Civil Response to Submissions

Issue B

Project Number:	191797 CAAA_CRTS
Report Issue Date:	04 May 2021
Report Status:	Final
Prepared by:	Eirian Crabbe
Checked by:	Stephen Brain

Taylor Thomson Whitting has been commissioned by Atlassian (the Applicant) to prepare this Civil Response to Submissions Report in response to the issues raised in by government agencies, community organisation groups and the public during the public exhibition of the proposed Atlassian Central State Significant Development (SSD) application (SSD-10405) in relation to the site at 8-10 Lee Street, Haymarket.

Figure 10 Extract of Civil SSDA Report Showing; Original Darling Harbour Flood Study – 1% AEP Flood Depths and Levels

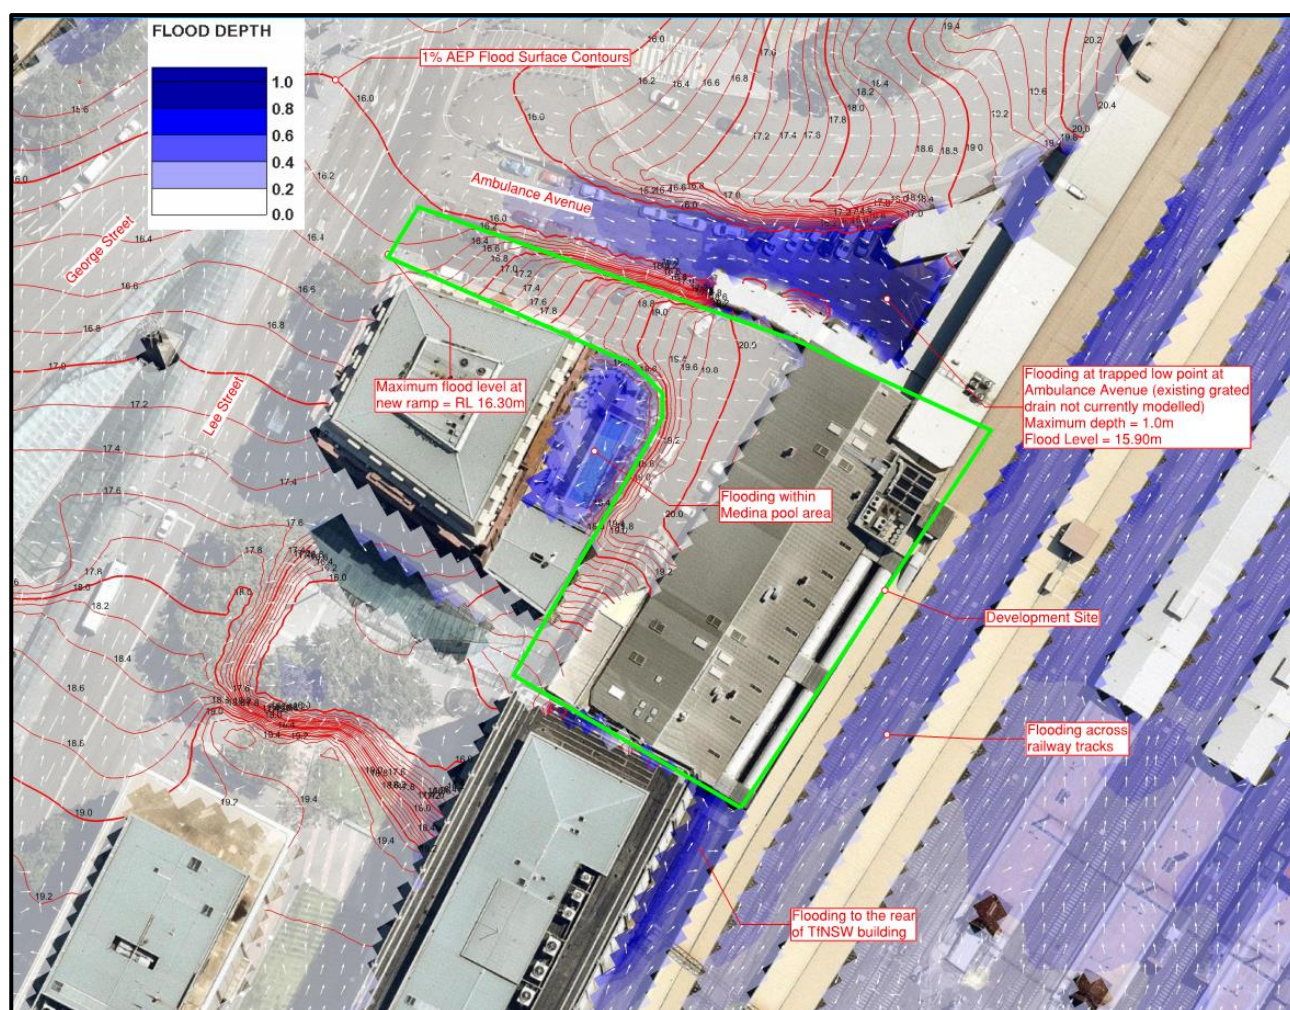
43. The City is concerned that the development is relying on a proposed stormwater network extension to reduce flood levels in Ambulance Avenue, which is unacceptable. All flood planning levels are to comply with the City's Interim Floodplain Management Policy. The following further information should be submitted for review prior to determination:

- A study regarding the practicability and constructability of the proposed stormwater network extension, regarding underground utilities in the area.
- Approval from Sydney Water for the proposed extension to connect to the Sydney Water trunk drain.
- Failsafe design of the inlet structures in the Ambulance Avenue sag, for example blockage of the inlets.

As described in the TTW Civil SSDA Report (Rev F, 25 Nov 202), section 5.1 confirms that there is no overland flow path away from the trapped low point in Ambulance Avenue. The existing trapped low point is enclosed on 3 sides by existing walls and buildings and is a fully impermeable surface used as an access/maintenance road, refer to figure 10 extract of the report below.

As its definition implies, a trapped low point has no overland flow path away from it and traps any rainfall, overland flow or surface runoff entering it. The only ways to dispose of stormwater from a trapped low point is by gravity drainage, infiltration, or pumping. As the existing (and future) surface is fully impermeable, infiltration of this trapped low point is not an option. Draining the trapped low point by pumping requires ongoing maintenance and carries greater flood risk in the event of pump failure.

The most suitable way to drain a trapped low point is by providing stormwater inlets and pipes that are drained by gravity and conveyed to areas that lie below the trapped low point. This is a standard method of stormwater drainage used for trapped low points and is currently the existing method used for draining this area. The proposed stormwater amplification increases the inlet and pipe capacity to improve the efficiency of draining this trapped low point and reduces flood risk to the development and to the wider

Central Station Precinct. As confirmed in the TTW Civil SSDA Report, section 5.4, the proposed stormwater works reduce flood levels with no negative impact elsewhere.

Furthermore, the proposed Central Precinct Redevelopment Program concept allows for regrading this area to remove the trapped low point with a continuous overland flow path out towards George Street. This Atlassian development does not rely on this regrading and removal of the trapped low point, but it would mean that when these works are undertaken there will no longer be a trapped low point and the flood risk will be significantly reduced. The following points address the specific points raised by City of Sydney.

- a) A detailed services and utilities survey is currently being undertaken that will enable a detailed review of the practicality and constructability of the proposed stormwater. However, the proposed depth of the stormwater at up to 4m below the surface of the Lee Street is unlikely to clash with existing utilities and services that are generally located at much shallower depths. Further design progression of the proposed stormwater will take place following the SSDA approval as part of the design development.

- b) Approval from Sydney Water for the proposed stormwater connections to the existing Sydney Water trunk drain will be obtained through a Section 73 application. Consultation with Sydney Water is ongoing and it is likely that approval from Sydney Water will be obtained following the SSDA approval which can be conditioned with the consent.

- c) The flood model detailed in the TTW Civil SSDA Report, section 5.2 confirms that a blockage factor of 95% blockage has been applied to large grated inlet structure in Ambulance Avenue, in accordance with City of Sydney (CoS) drainage specification. The proposed inlet structure will be 25m long and 600mm wide, the likelihood of the full inlet area being completely blocked is extremely unlikely in any storm event. The ground floor levels are compliant with CoS interim Floodplain Management Policy and are set above the 1% AEP flood level with basement entrances raised or protected with internal flood gates to provide protection up to the PMF and 1% AEP +500mm flood level.

Furthermore, the trapped low point is proposed to be removed and regraded as part of the Central Precinct Redevelopment Program. The likelihood of full blockage of the system and an extreme storm event (1% AEP or greater) occurring within the interim period, before the trapped low point is removed, is extremely unlikely.
